# Proposed Bala Falls Power Station *Inconsistent Information Provided*

Vertical Cross-section of Proposed Hydro-electric Power Station

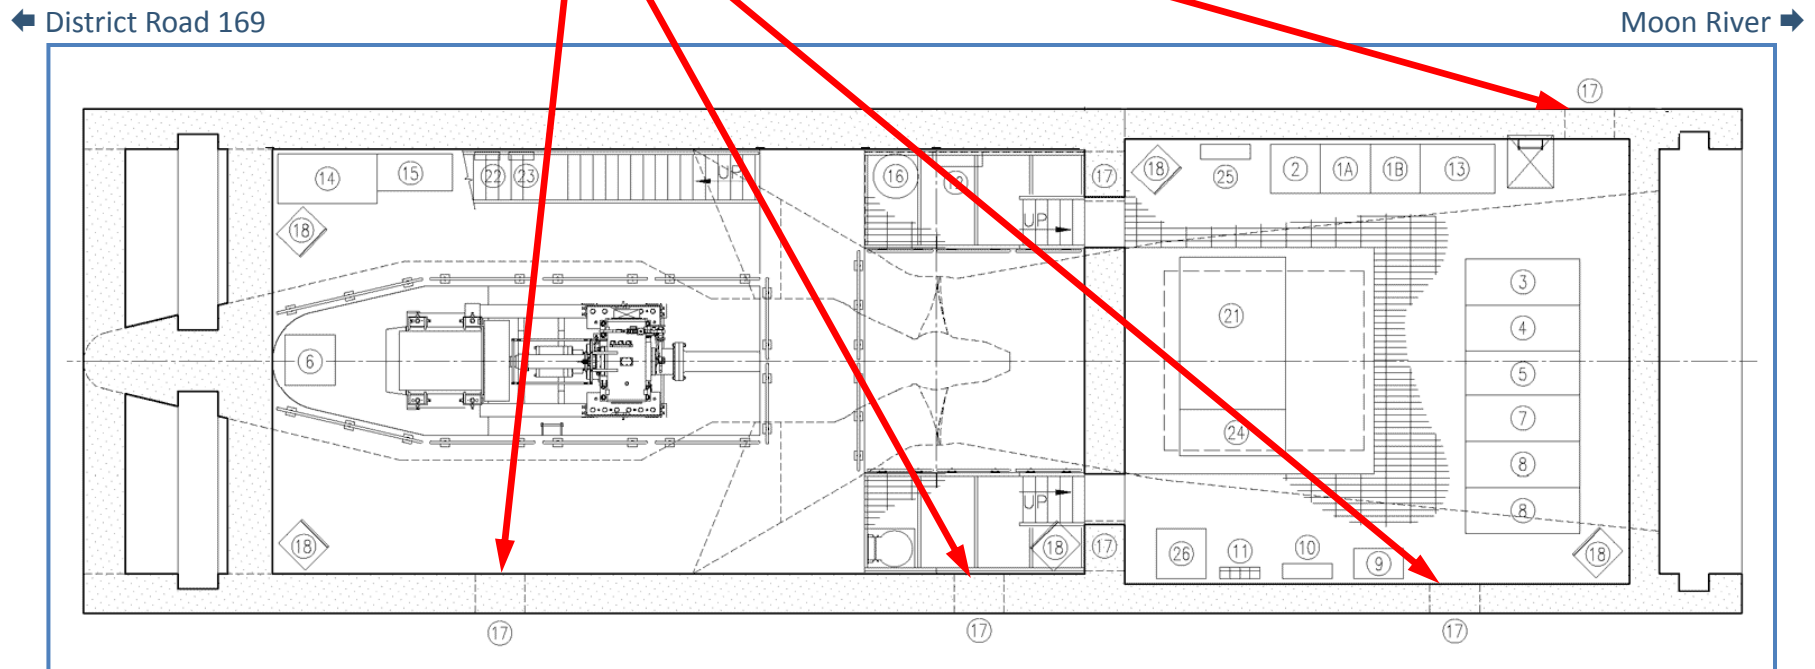
- But the proponent's own drawings show a 5'-high, 25'-wide roller gate hoist mechanism blocking the view
  - And the top of the 30'-wide roller gate
  - And the 4' x 3½' emergency egress hatch and guardrail
  - Would people even be allowed on the lookout as there is a 44 kV, 5 MVA transformer and switchgear directly below

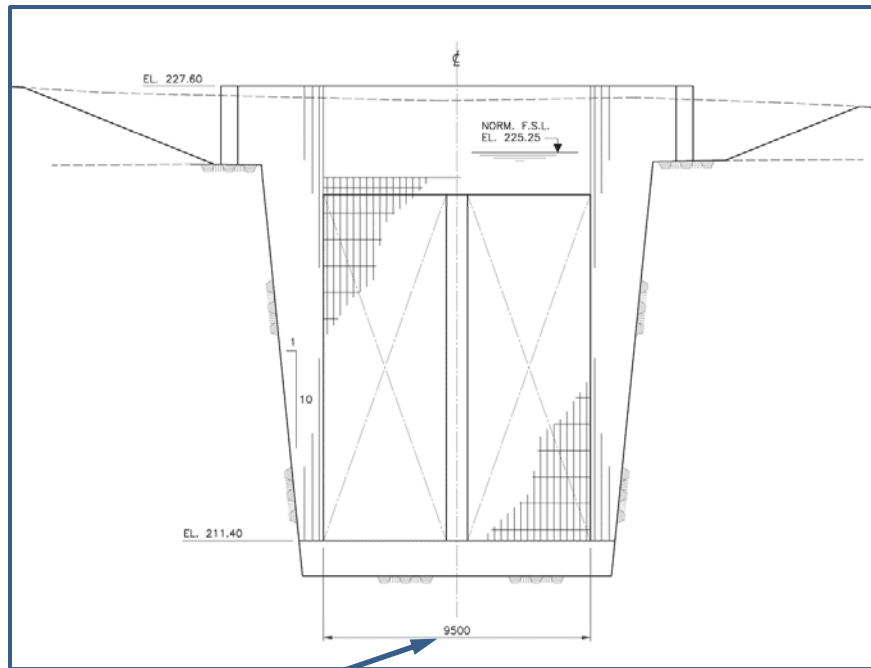
- The intake is shown as a calm pond surrounded by grass
  - But to prevent erosion, the sides of the intake would need to be concrete all the way to the channel
    - ▶ And the water would be moving at a high velocity

Where are the huge red warning signs

Will there need to be barbed-wire fencing – the same proposed operator has installed this at their other sites in the area

Need more room for guy cleaning trash rack and his safety harness anchor

Up to 80 tons of water per second into the intake

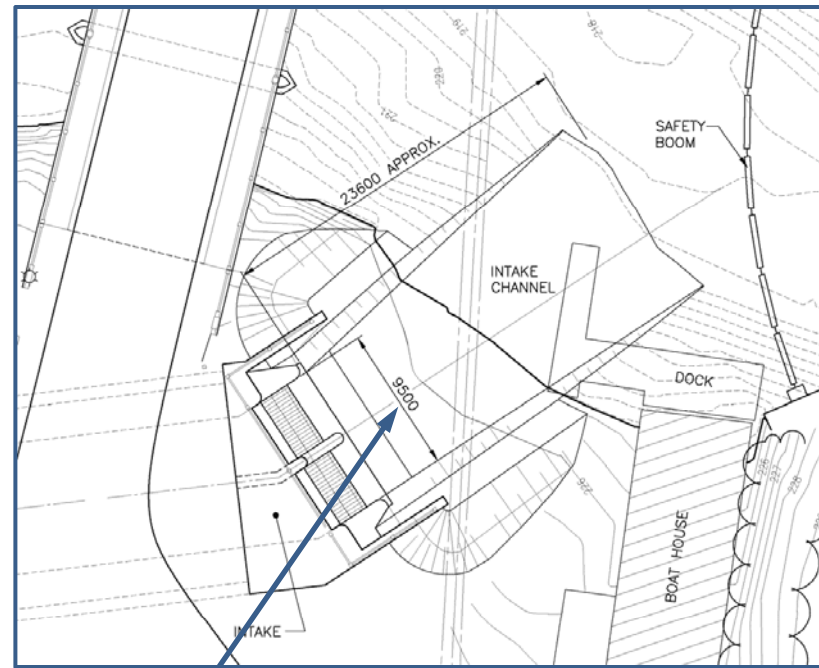
- The proponent agreed the width of the intake would need to be increased to 11.6 m
  - Yet the drawings still show the intake as 9.5 m wide

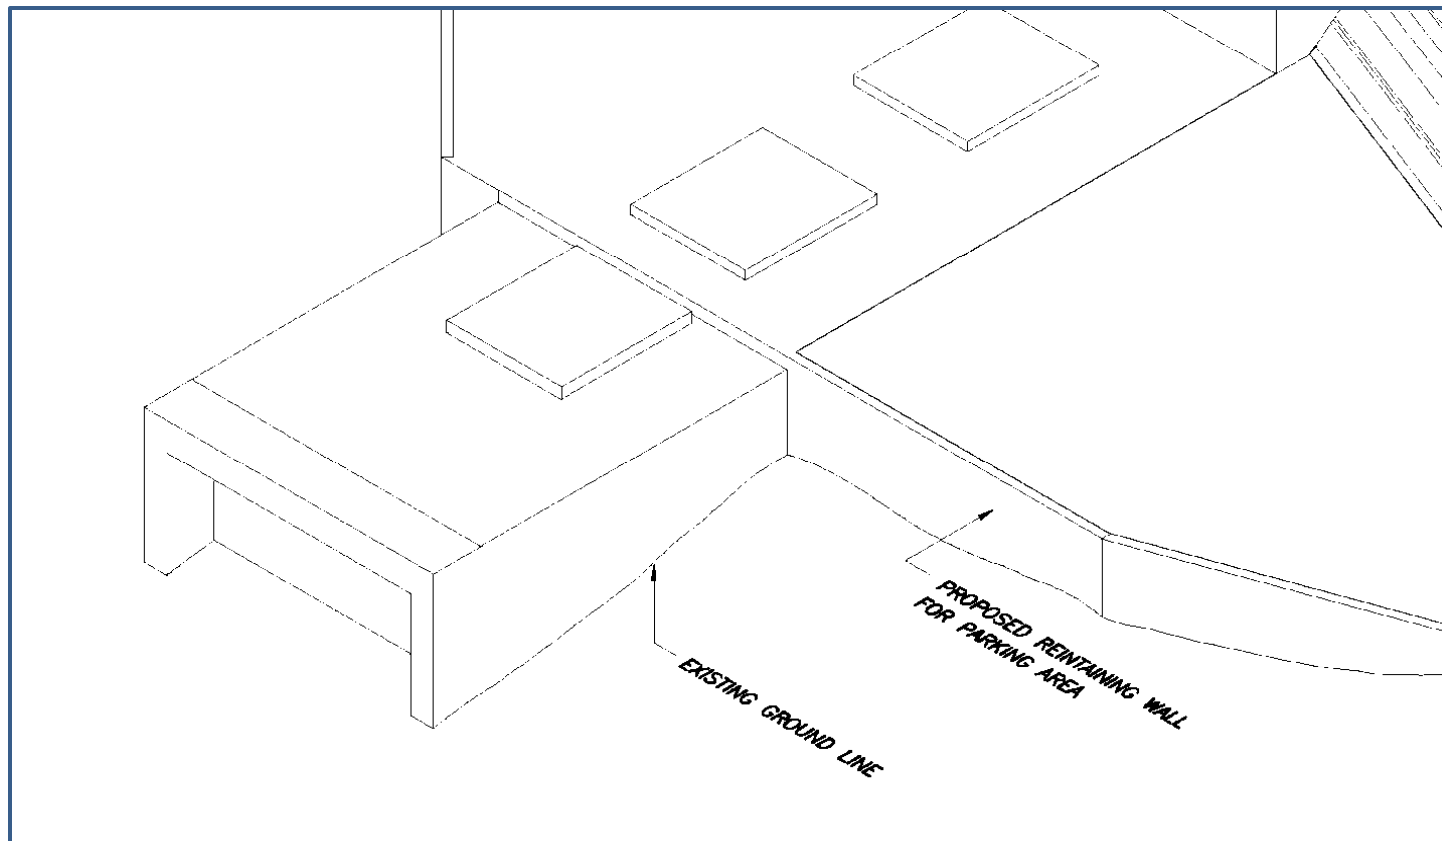
- No information presented for the driveway retaining wall (height, location, length, fencing ...)
